May 30, 2025

SUBJECT: MCPC #18-0322-008
SOPI – 1 Belmont Avenue

January 30, 2025

Re: MCPC #18-0322-007
Plan Name: 1 Belmont Avenue
(17,700 sq. ft. commercial on approximately 6.76 acres)
Situate: City Avenue (N); Belmont Avenue (E)
Lower Merion Township

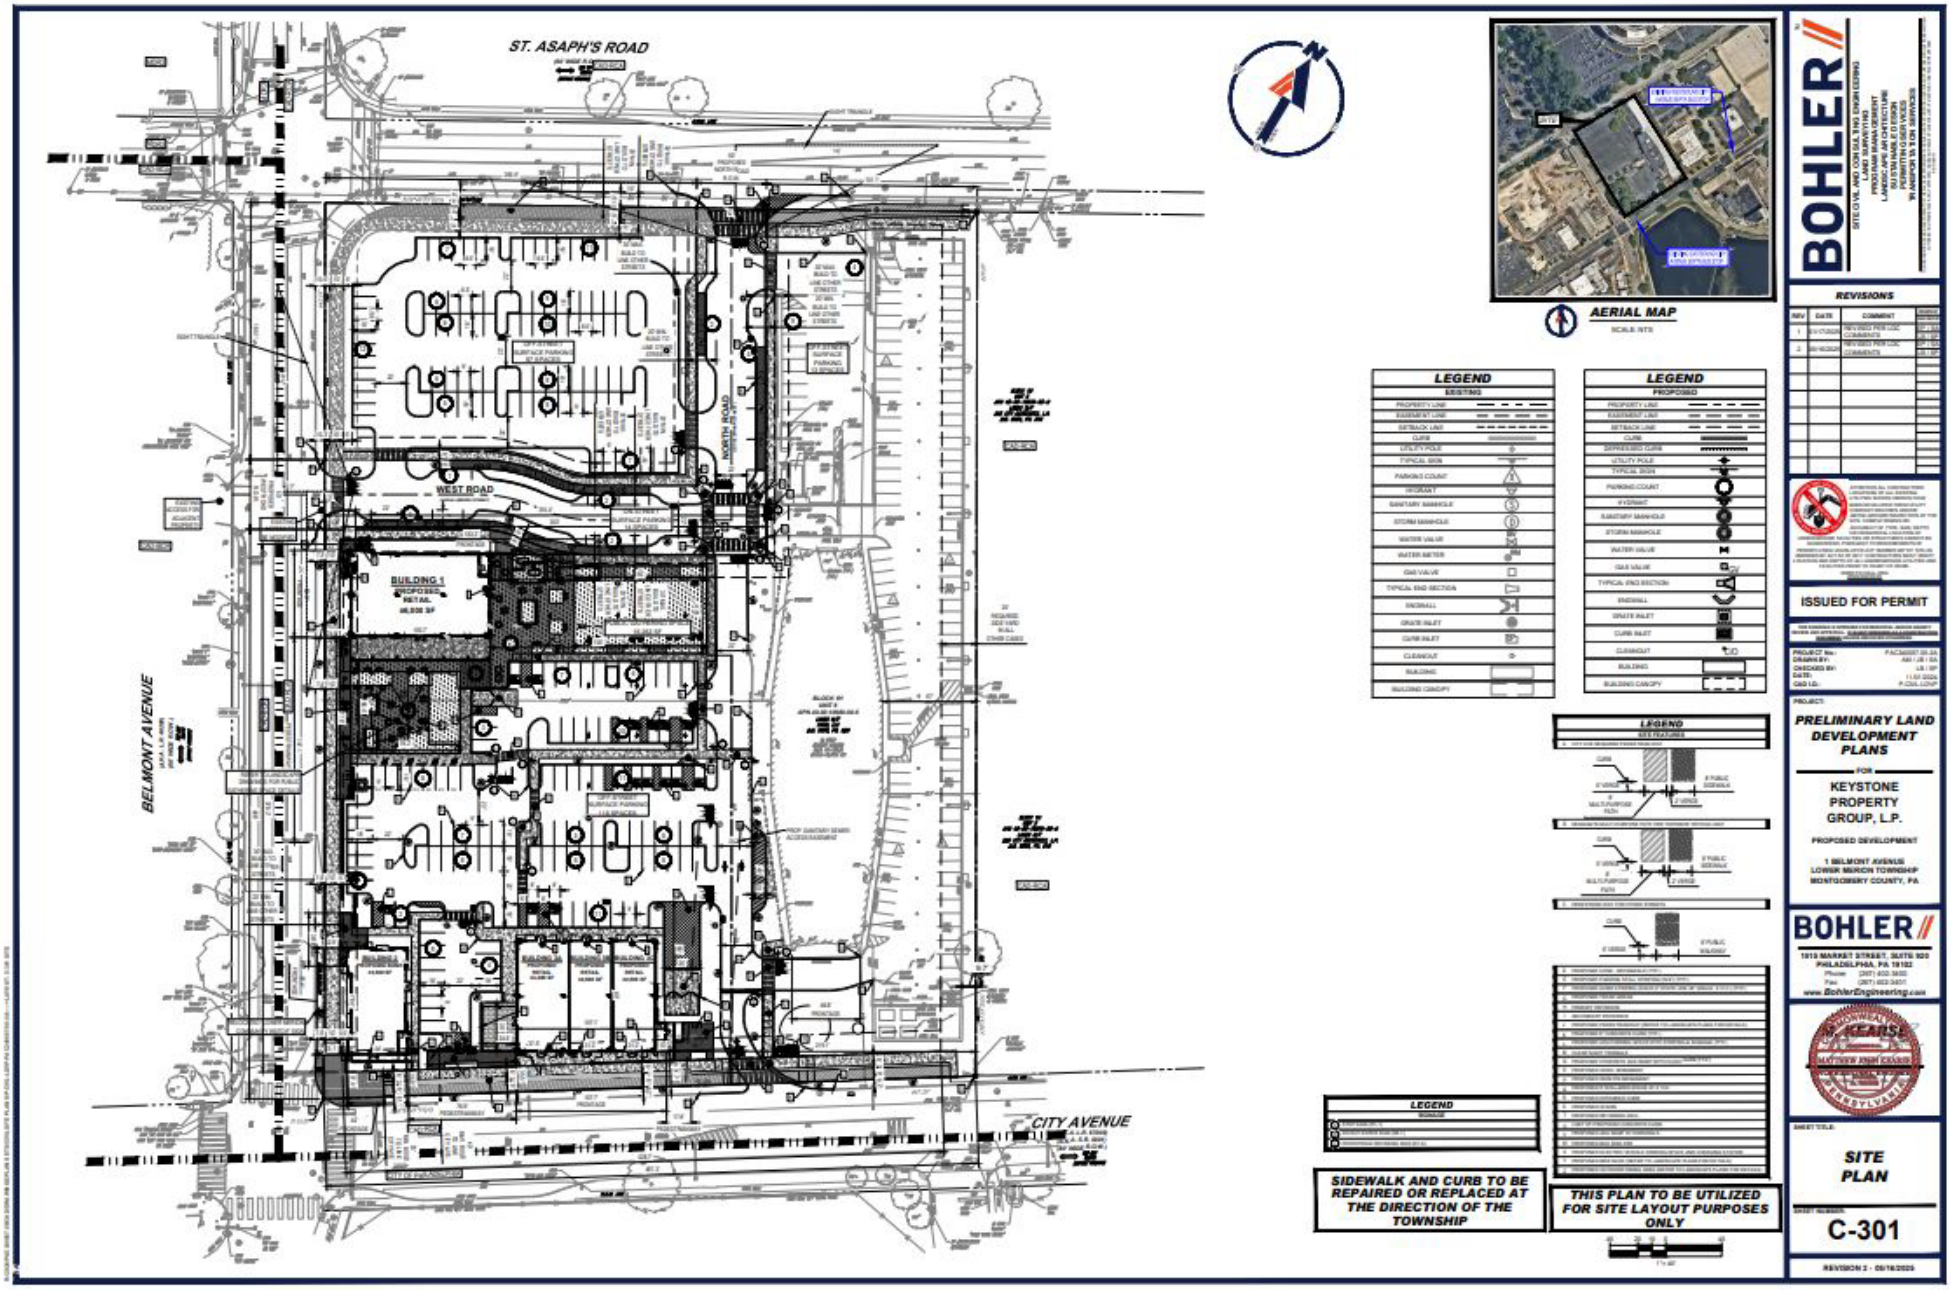
- Minimum Building Height & Architectural Design. Section 155-6.6.D.(5) of the township's zoning ordinance establishes a minimum building height for the entire CAD-RCA district of 2 stories, or 28 feet, and that "the second-story floor area shall be equal to or greater than 75% of the grade-level building area." It appears that the applicant proposes single-story buildings. In addition, we encourage the

- Public Gathering Space Design. Table 6.6.5 of the township's zoning ordinance requires a minimum of 30% of the public gathering space to be landscaped. Sheet 1 of 11 of the landscape plan indicates that 15.9% of the public gathering space is proposed to be landscaped. Overall, we encourage the applicant to continue to coordinate with township staff to ensure their proposed public gathering space complies with the standards for public gathering space contained in both the township's zoning ordinance and subdivision and land development ordinance.

- Greening Standards. We wish to reiterate that it appears that the applicant is using some elements of the plan that are required by other sections of the zoning (e.g., public gathering space for a FAR bonus, bike parking) towards the required greening standards.

- Landscape Plan. The landscaping requirements table on Sheet 1 of 11 of the landscape plan set does not appear to contain calculations demonstrating compliance with the buffer requirements around site elements such as dumpsters and loading areas (see §135-5.2.F.).

- Handicapped Parking and Access to Existing Office Building. Several handicapped parking spaces are shown on either side of a pedestrian walkway in the southern parking lot near the entrance to the existing office building. An ADA curb ramp is shown on either side of the pedestrian walkway connecting to a loading zone between ADA parking spaces on the civil plan set; however, no curb ramps in these locations are shown on the landscape plan.

- Proposed Bus Shelter. We commend the applicant for proposing to include a bus shelter as part of their development; however, the location of the bus shelter is not shown consistently across the civil site plan and landscape plan submissions. We wish to reiterate that the township has detailed design guidelines for bus stops and bus shelters in §135-4.9.K. of the township's subdivision and land development ordinance. We encourage the applicant to coordinate with SEPTA and the township to ensure the placement and design of the proposed bus shelter complies with all applicable standards.

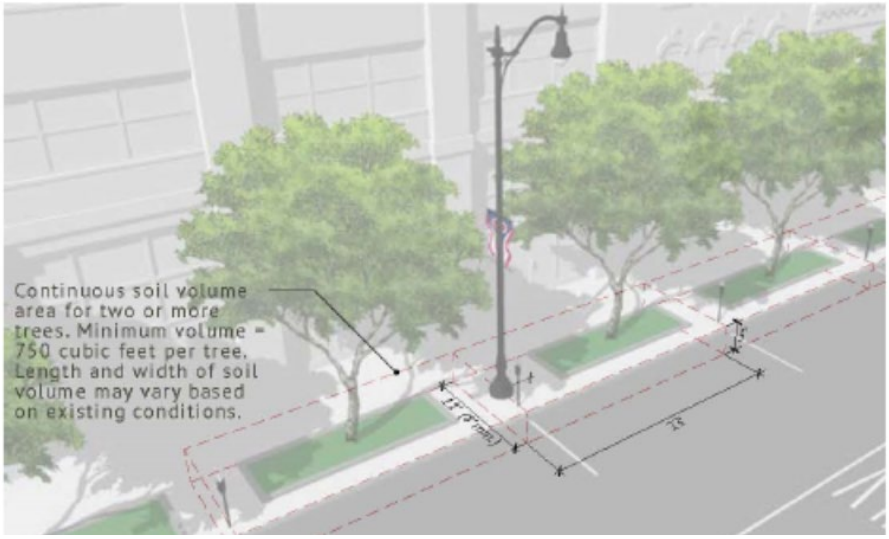
A. Handicapped Parking and Access to Existing Office Building. Several handicapped parking spaces are shown on either side of a pedestrian walkway in the southern parking lot near the entrance to the existing office building. An ADA curb ramp is shown on either side of the pedestrian walkway connecting to a loading zone between ADA parking spaces on the civil plan set; however, no curb ramps in these locations are shown on the landscape plan.
